**Subject: Rumford Falls Hydroelectric Project (FERC No. 2333-094)
Response to FERC Additional Information Requests for the Final License
Application**

Rumford Falls Hydroelectric Project (FERC No. 2333)
Response to FERC Additional Information Requests for Final License Application
March 6, 2023

**A RESPONSE TO FERC ADDITIONAL INFORMATION
REQUESTS**

**FIGURE 1.0-1
EXPLANATION MAP FOR PROPOSED PROJECT BOUNDARY**

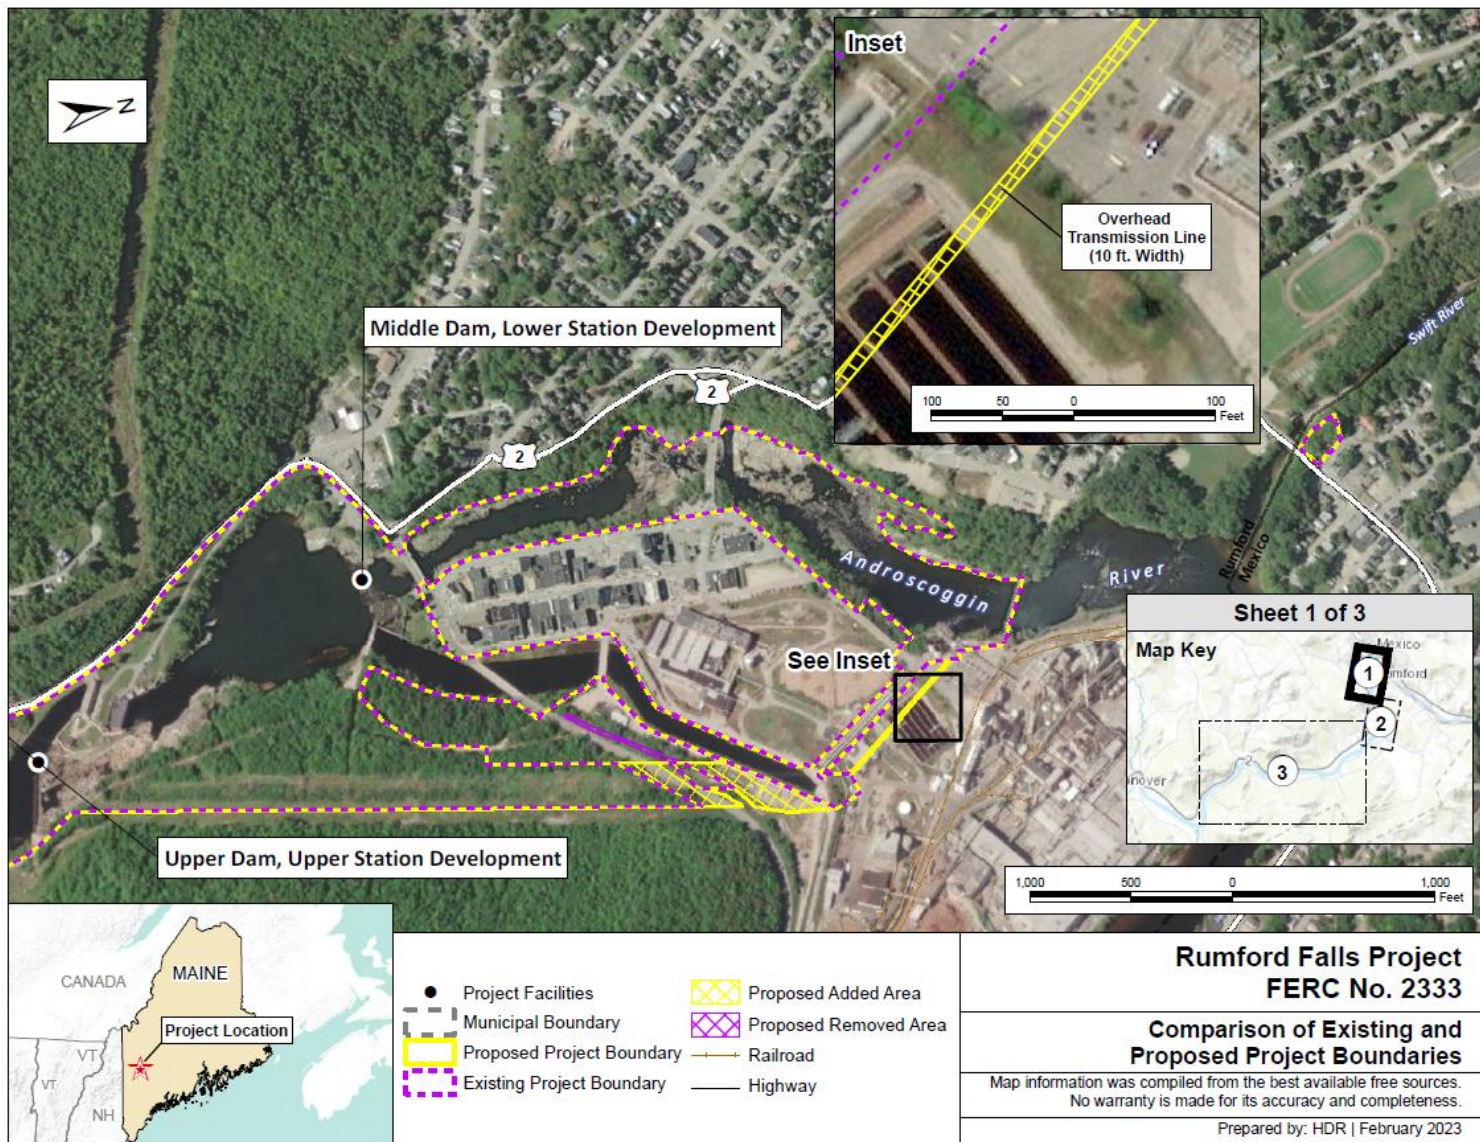
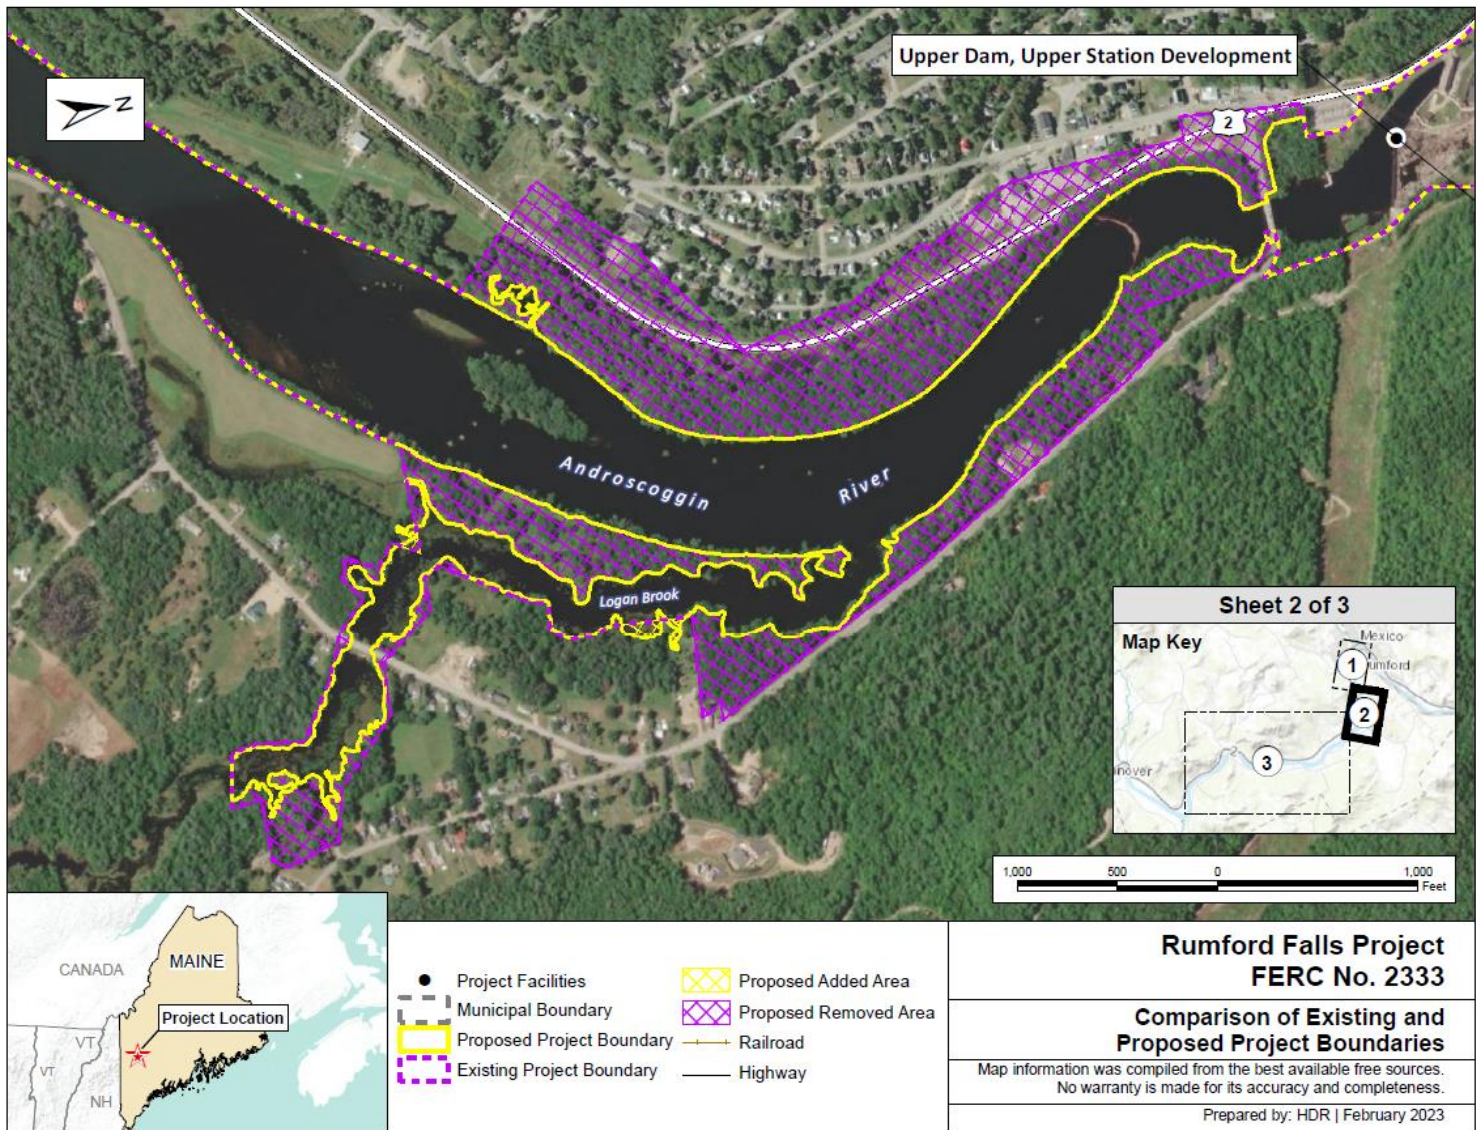
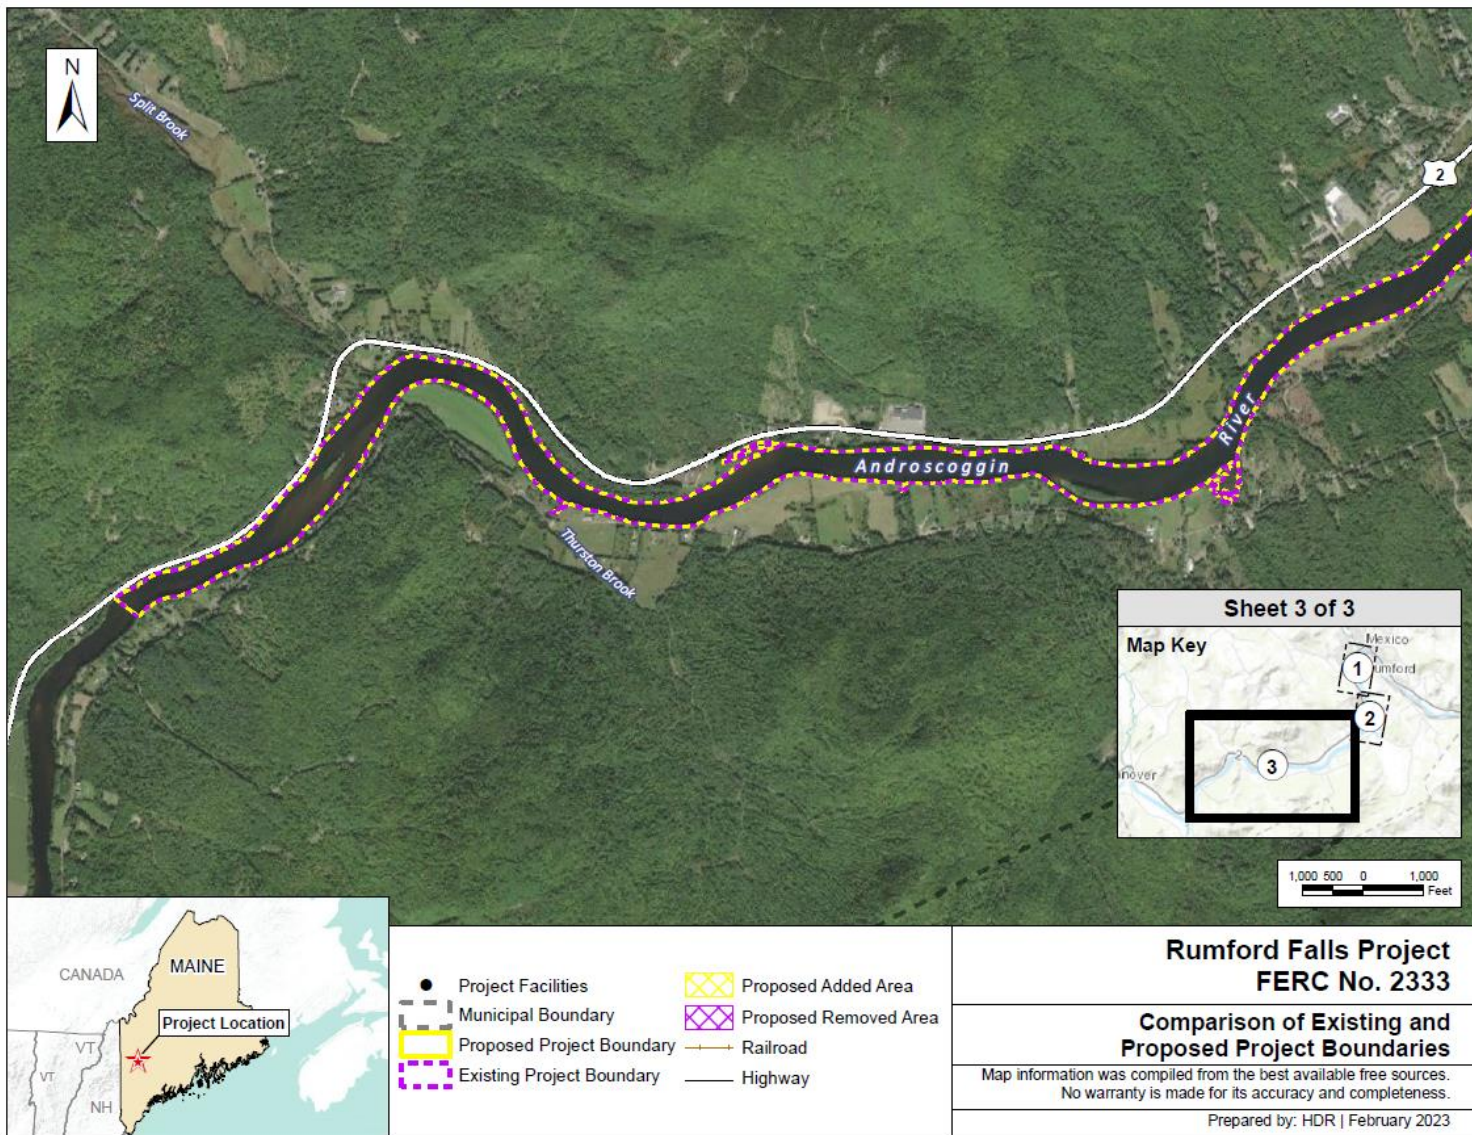
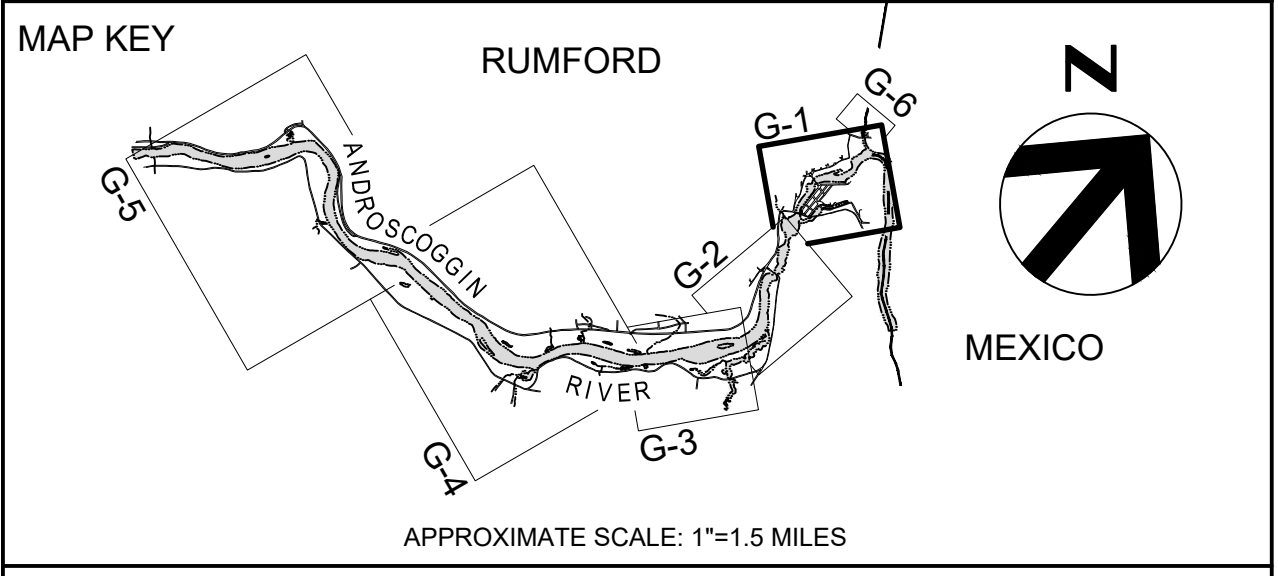
4. *Section 4.41(h)(2) of the Commission's regulations requires that Exhibit G include a project boundary that encloses all project works and other features described in Exhibit A that are to be licensed. The project boundary in the Exhibit G-1 drawing does not encompass the entirety of transmission lines 2 and 3 and the Generator Set Up (GSU) substation. Also, the project boundary shown in Exhibit G-2 does not encompass the entire project impoundment, specifically around the Logan Brook tributary. Please revise your Exhibit G to include a corrected project boundary or explain why these features were not included.*

- Expand the Project Boundary by approximately 2.8 acres to include the Project's transmission lines (i.e., lines 2, 3, and 5A/B), Generator Step-Up (GSU) substation, and CMP connection (See Figure 1.0-1 and Exhibit map G-1);
- Adjust the existing Project Boundary along the shoreline of the inlet of Logan Brook to follow the normal maximum surface elevation of the Upper Dam impoundment (i.e., 601.24 feet USGS¹), which will result in the inclusion of approximately 0.6 acre of water into the Project Boundary (See Figure 1.0-2 and Exhibit maps G-1 and G-2);
- Remove a total of approximately 82 acres of land along the western and eastern shore (includes the land removed around Logan Brook) of the Upper Dam impoundment that extends above the normal maximum surface elevation of the impoundment (i.e., 601.24 feet USGS), consistent with the boundary on the rest of the impoundment (See

- Remove approximately 0.3 acre of land located between the Middle Canal and Route 108 (See Figure 1.0-1 and Exhibit map G-1). These lands are not necessary for the operation or maintenance of the Project or for other Project purposes.
